Our Ref: N:\37672 Northbank\Worddocs\Report\NSW DoPI Additional Information Request November 2012

NORTHBANK ENTERPRISE HUB (MP 10_0185)

- SECTION ID
- SHEET NO.
- APPROXIMATE EXISTING CATCHMENT TO NPWS FLOODGATE
- FILL EXTENTS
- DEMOLISHED HOUSES

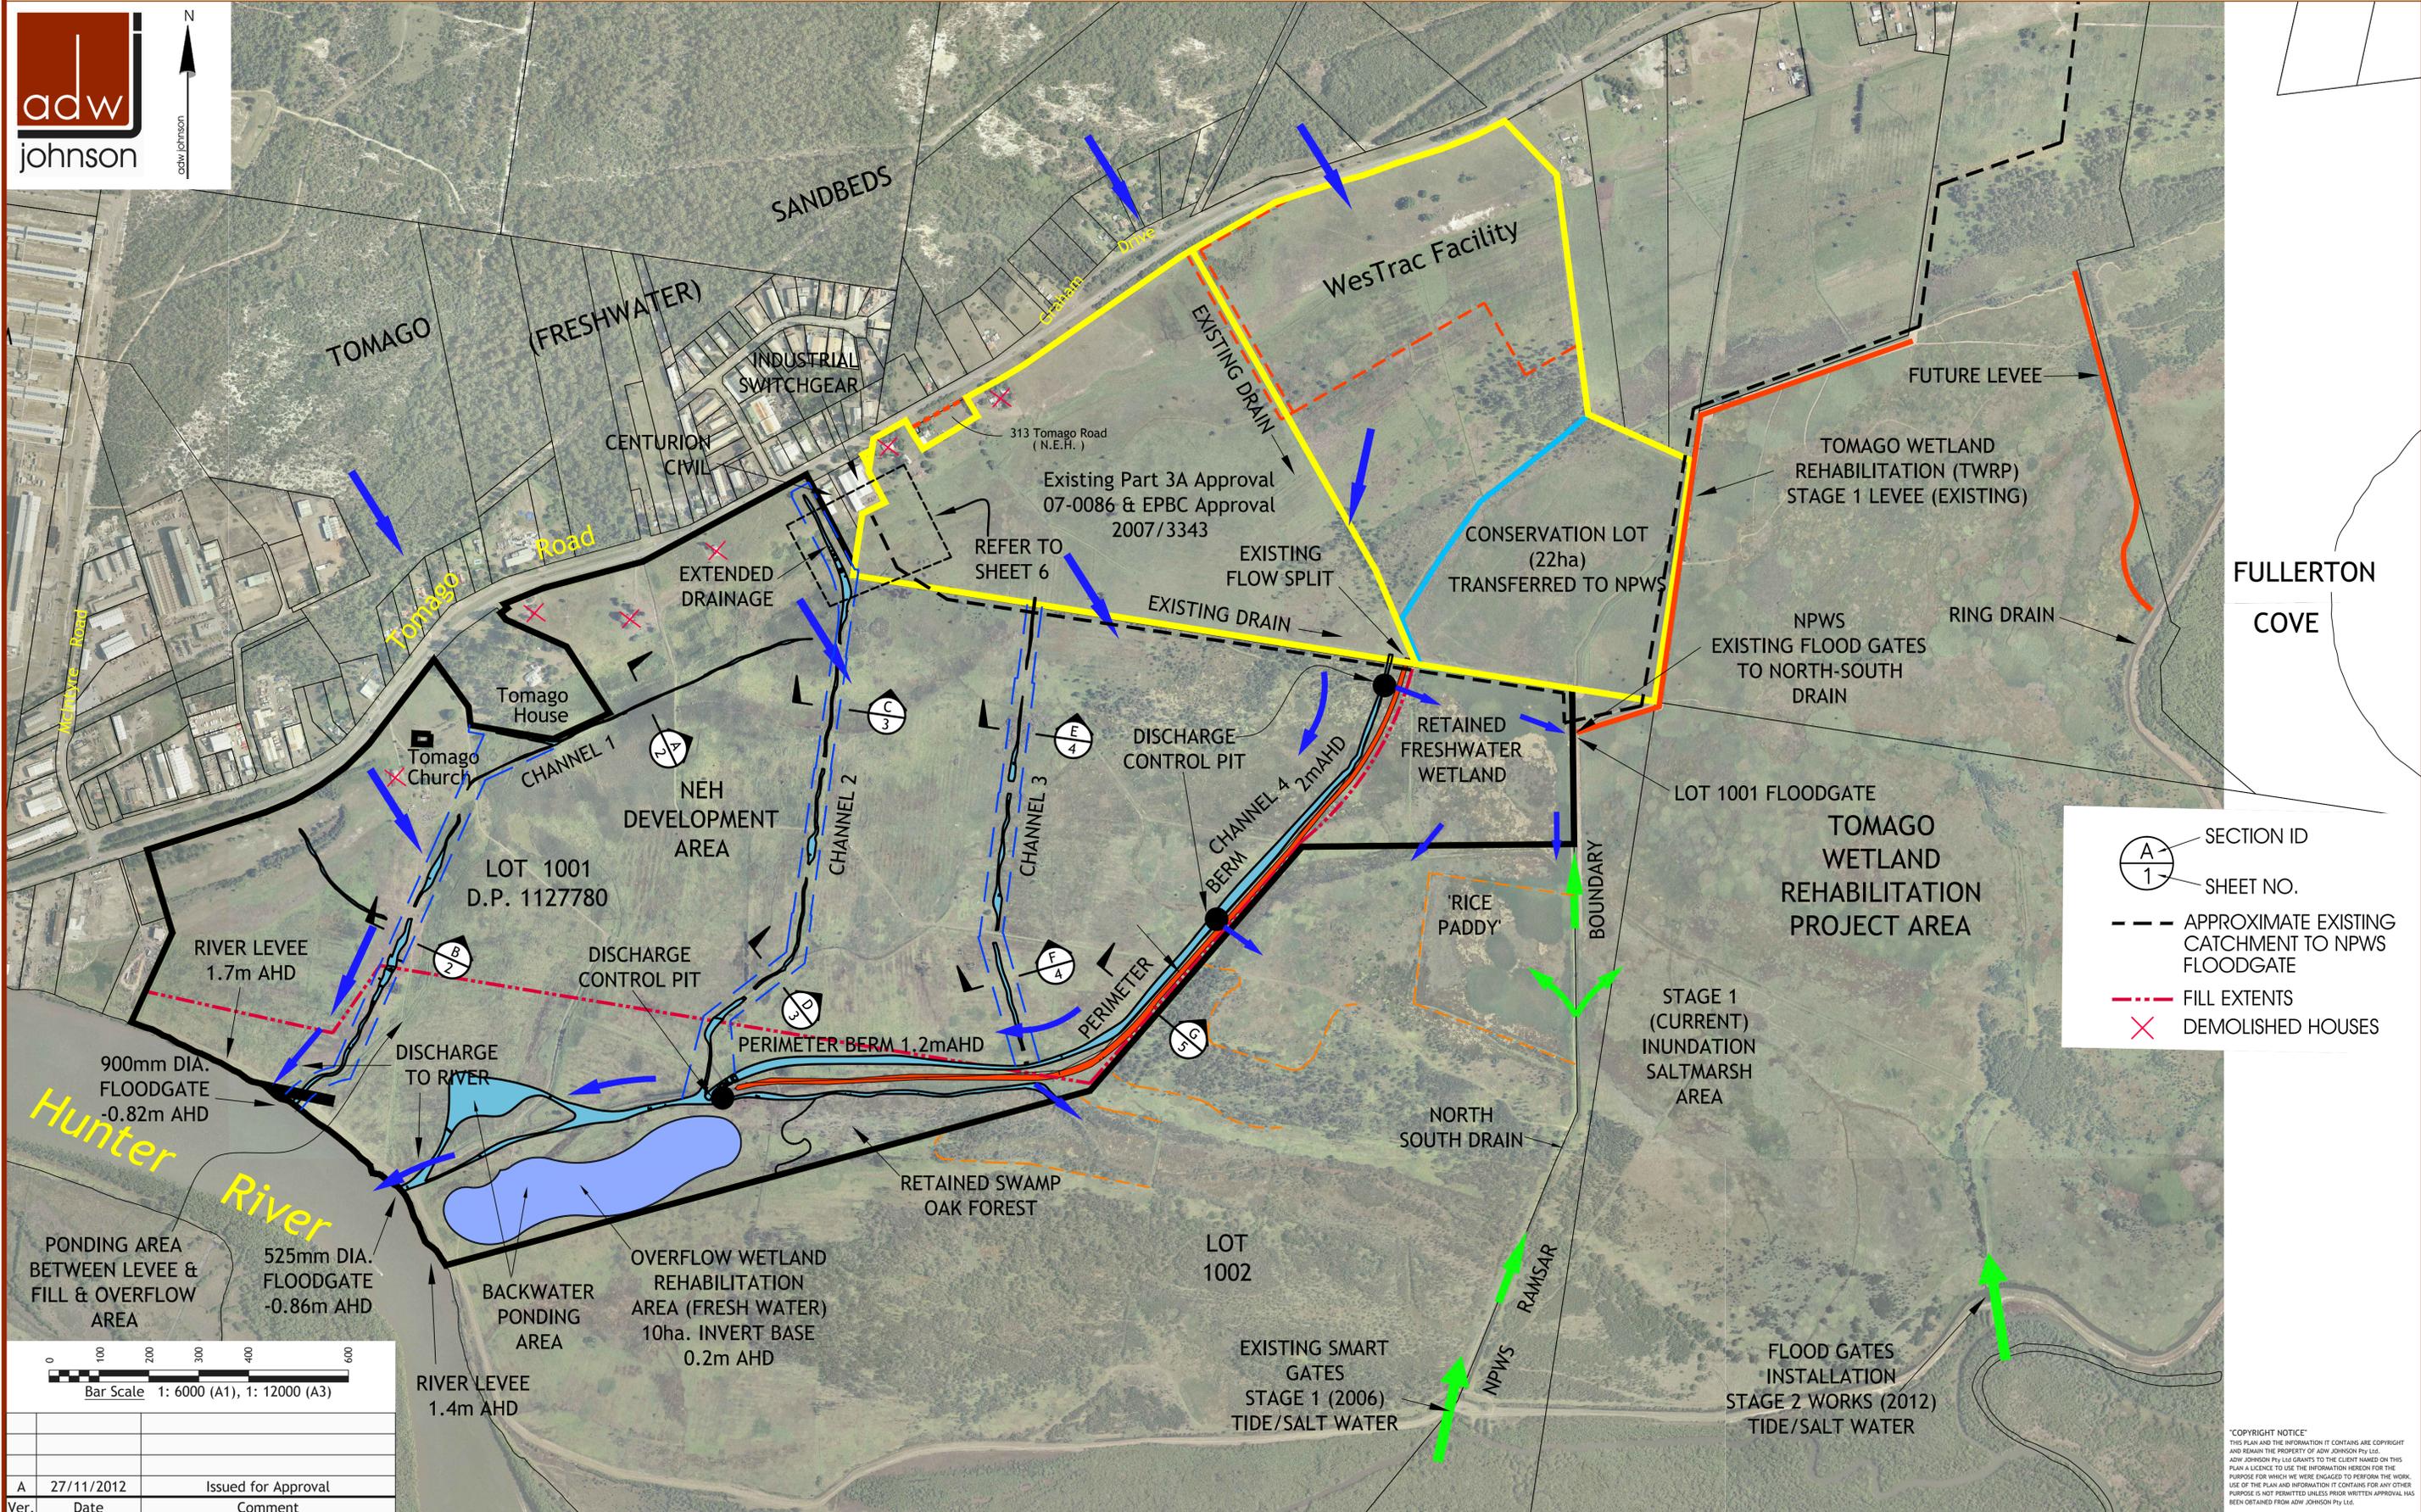
The existing drains currently have a function to keep groundwater levels low through Lot 1001. This was the purpose of the drains through the previous, historic landuses to enable pasture grass growth over the lands. Figure 49 from the EAR shows the extensive groundwater catchment overflow from the Tomago Sandbeds upslope.

Additionally, similar drain bases to the existing drains will be excavated in Channels 1, 3 and 4. Channel 4 being the perimeter drain within the development footprint adjacent to the perimeter berm. Channel widths are 28-41m consistent with Figure 6-1 from BMT WBM local Flooding and Drainage Assessment.

Refer to Sheet 1 for details.

SECTION A
TYPICAL
SCALE 1:75

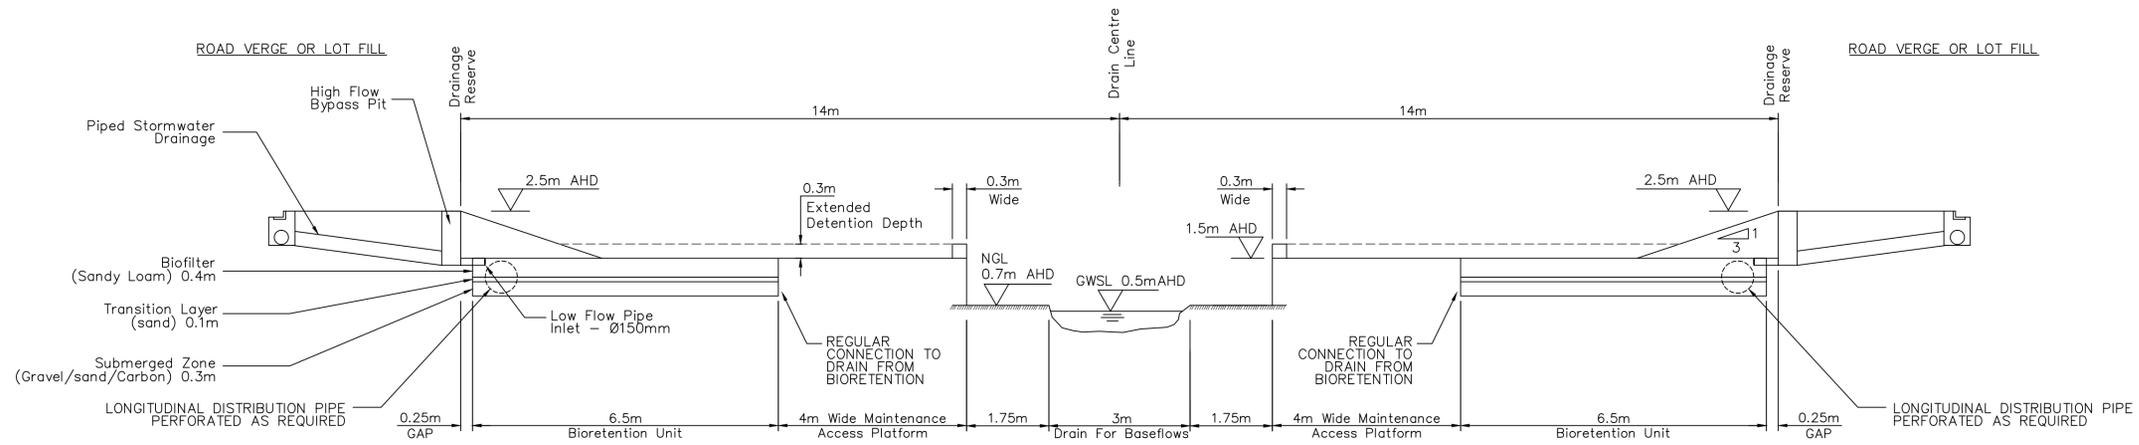
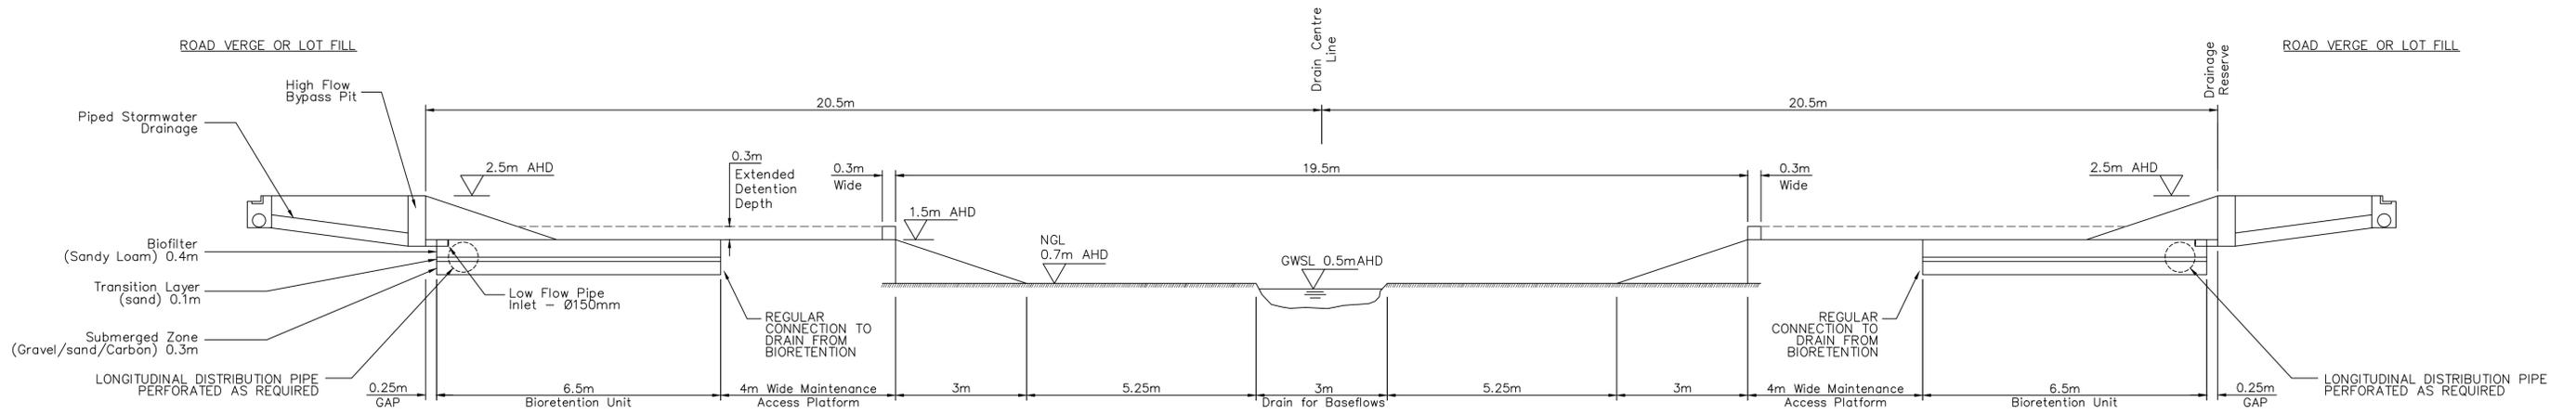
Dot Point 1 – Existing drains to be maintained so as to provide for positive drainage of the bioretention systems were not represented in the Stormwater Assessment Report. Additional detail has been provided on the sections, refer to Attachment 'B'.

Dot Point 2 – In preparing this additional detail and information, it was considered that Section B was potentially not going to positively drain in some instances. As a result, additional excavation of a deeper baseflow drain within Channel 3, cut below natural would be excavated for certainty on positive drainage of the bioretention systems. The ASSMP already covers drain excavation into the natural ground for the perimeter drain and drain from Tomago House.

SECTION ID
SHEET NO.

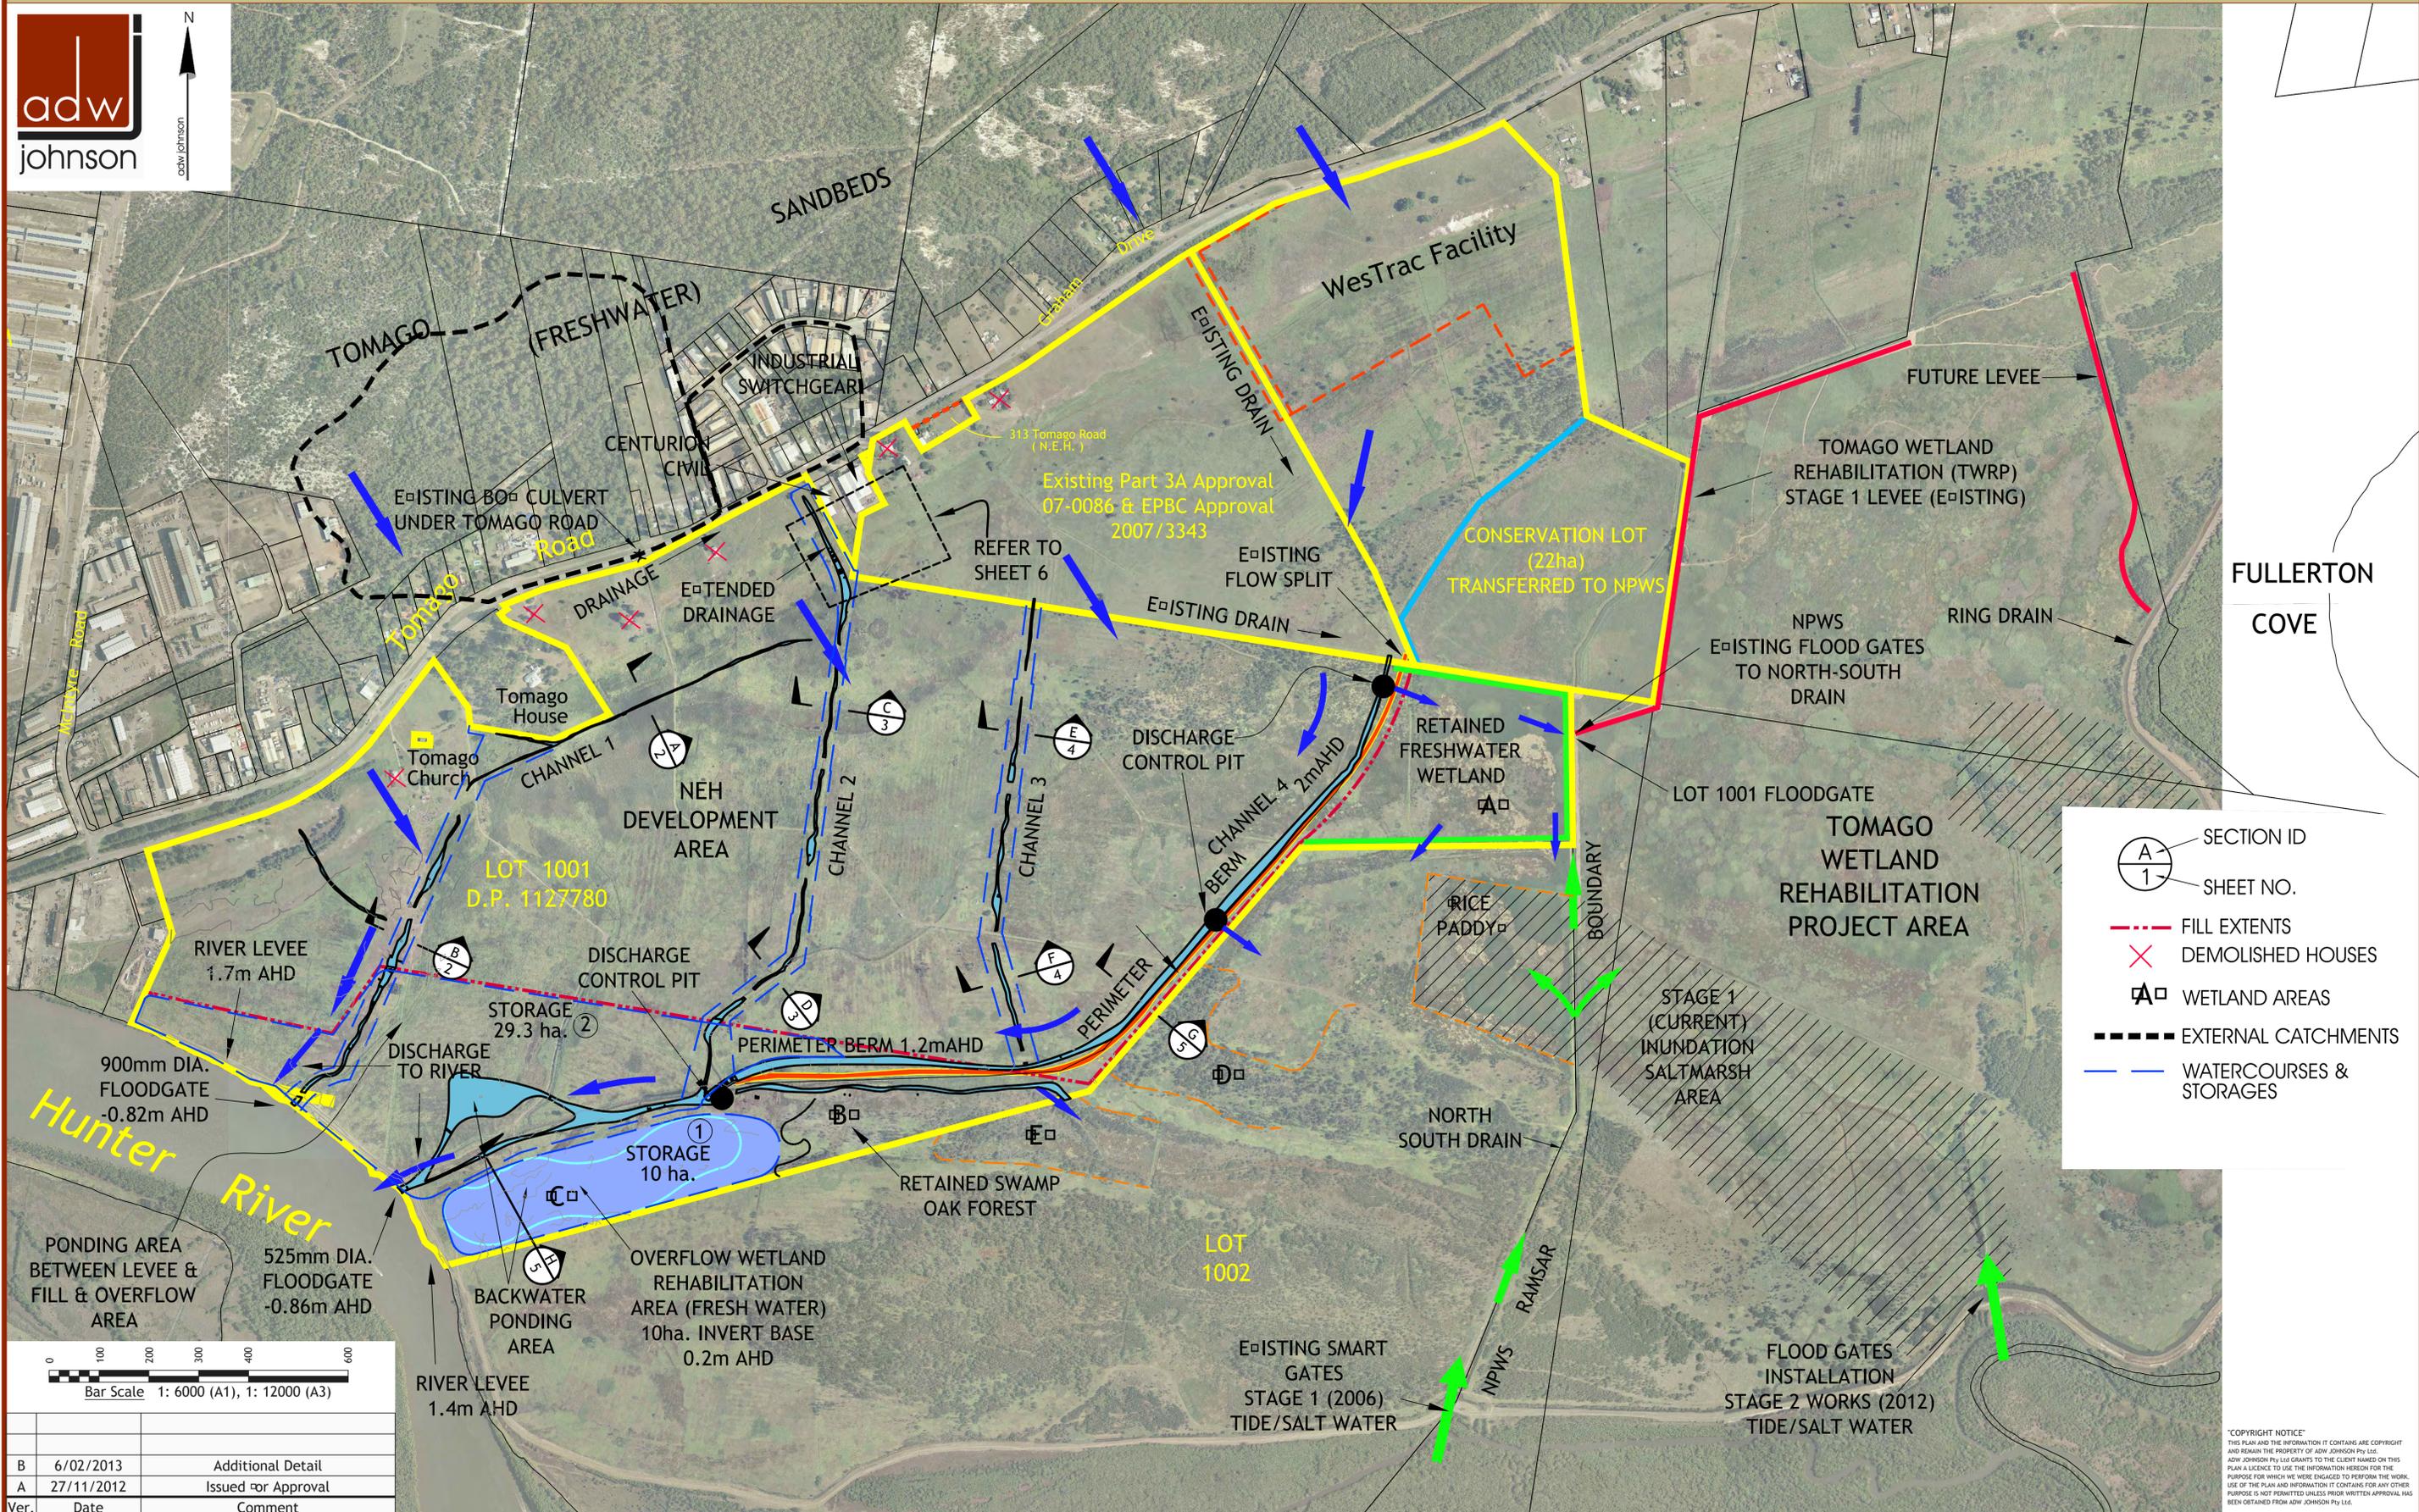
- *We note that there is low lying property upstream (Sheet 6 of 6) which could potentially be affected by afflux noting the long distances from the outlets to the low lying land on these properties;*
- *In consideration of all these issues, and as recommended in our reply on 16 November 2012, we recommend undertaking hydraulic modelling of the drainage system in the minor and major events to show hydraulic grade lines of the stormwater drainage system in an appropriate range of minor events with durations relevant to the length of drawdown.*

External catchment delineation has been added to Sheet 1 of the existing set of plan sheets from the previously submitted Attachment 'B' (see submission dated 12 December 2012). Survey has confirmed that the box culvert under Tomago Road east of Tomago House has an invert level of 2.3mAHD. The box culvert is 1.2m wide x 0.3 high. The upslope catchment area of Lot 1001 is approximately 45ha over highly permeable sands and contains a number of sinks or low points which would accumulate stormwater prior to runoff to the culvert. Surface runoff is expected to be very low, whilst contribution to groundwater flows will be very high by comparison to conventional stormwater runoff and infiltration. The culvert level does however give good indication for peak acceptable levels of ponding within Lot 1001 without impeding any upstream flows drained through this culvert. BMT WBM's peak flood level for Channel 2 which will take this runoff is approximately 2.1mAHD, indicating that flow is not impeded during this event. Similarly, piped drainage from the small industrial subdivision north of Centurion Civil and Industrial Switchgear also within the catchment is also unimpeded.

The BMT WBM report indicating 100ML of storage is referring to the overflow wetland storage of 10 hectares. The description didn't include any of the channel storage or aboveground storage of landscaped area adjacent to the overflow wetland. The ADWJ comment regarding 285ML is from Section 2 Analysis 'Channel storages in larger storms' summary in Attachment 'B' is a different reference. Further clarification of the storage areas is provided on Sheets 1 and 7.

The plan view attached (Sheet 1) has been revised to add the wetland locations of interest as per the Wetland Interface Strategy of the Environmental Assessment Report. The assessment is shown in Table 2 below.
